**RE: DISAPPROVAL
RESPONSE TO DISAPPROVAL INVESTIGATION REPORT SOLID WASTE MANAGEMENT
UNITS (SWMU) NO. 4 OLD BURN PIT AND NO. 5 LANDFILL AREAS
WESTERN REFINING SOUTHWEST INC., GALLUP REFINERY
EPA ID # NMD000333211
HWB-WRG-17-006**

**RE: Response to Disapproval
Investigation Report Solid Waste Management Units (SWMU)
No. 4 Old Burn Pit and No. 5 Landfill Areas
Marathon Petroleum Company LP, Gallup Refinery
(dba Western Refining Southwest LLC)
EPA ID# NMD000333211
HWB-WRG-17-006**

**RE: Response to Disapproval
Response to Disapproval Investigation Report Solid Waste Management Units
(SWMU)
No. 4 Old Burn Pit and No. 5 Landfill Areas
Marathon Petroleum Company LP, Gallup Refinery
(dba Western Refining Southwest LLC)
EPA ID# NMD000333211
HWB-WRG-17-006**

**RE: DISAPPROVAL
RESPONSE TO DISAPPROVAL, RESPONSE TO DISAPPROVAL INVESTIGATION REPORT
SOLID WASTE MANAGEMENT UNITS (SWMU) NO. 4 OLD BURN PIT AND NO. 5
LANDFILL AREAS [DATED JULY 7, 2021]
RESPONSE TO DISAPPROVAL INVESTIGATION REPORT SOLID WASTE MANAGEMENT
UNITS (SWMU) NO. 4 OLD BURN PIT AND NO. 5 LANDFILL AREAS [DATED JUNE 30,
2021]
WESTERN REFINING SOUTHWEST INC., GALLUP REFINERY
EPA ID # NMD000333211
HWB-WRG-17-006**

EB-LIF-103

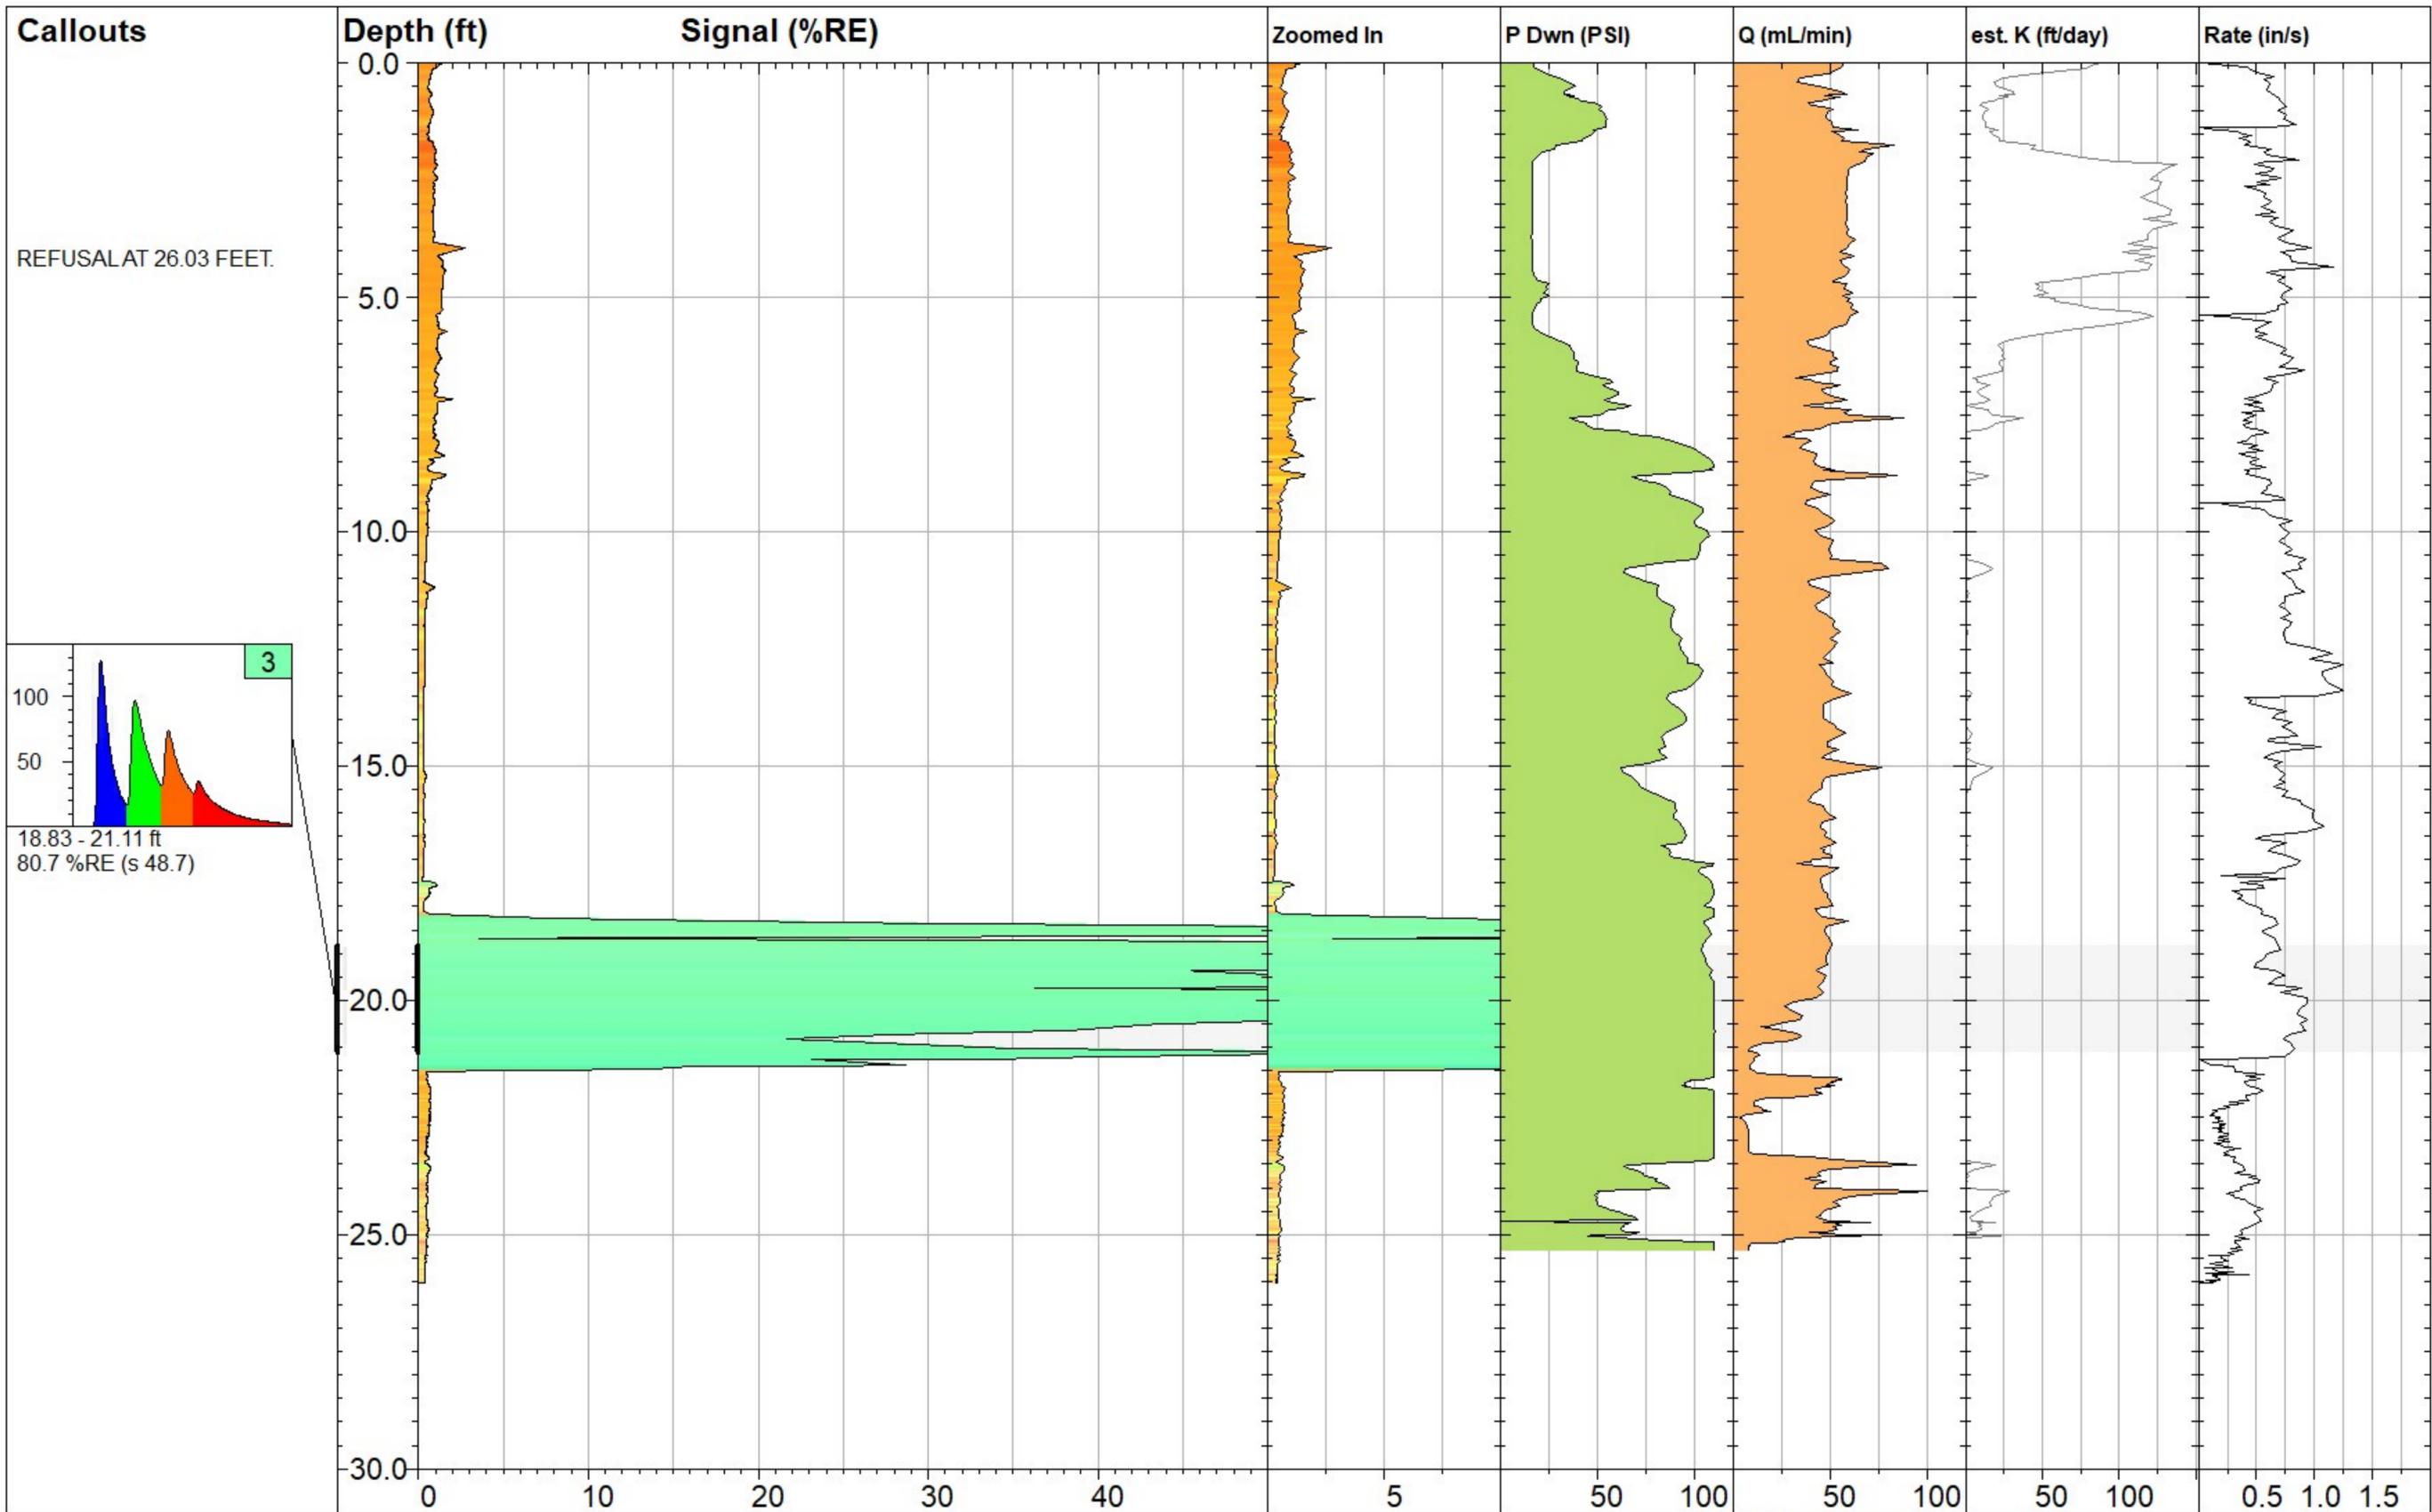
In addition, the log for LIF boring EB-LIF-103 was also included in Appendix B but the elevated LIF responses recorded in the log were not discussed in the response. The EB-LIF-103 boring log indicates the presence of NAPL at depths between 16 feet and 23 feet below ground surface (bgs) which may be consistent with the depth of the water table. Include the discussion regarding the elevated LIF responses relative to the investigation of SWMUs 4 and 5 in the revised Report.
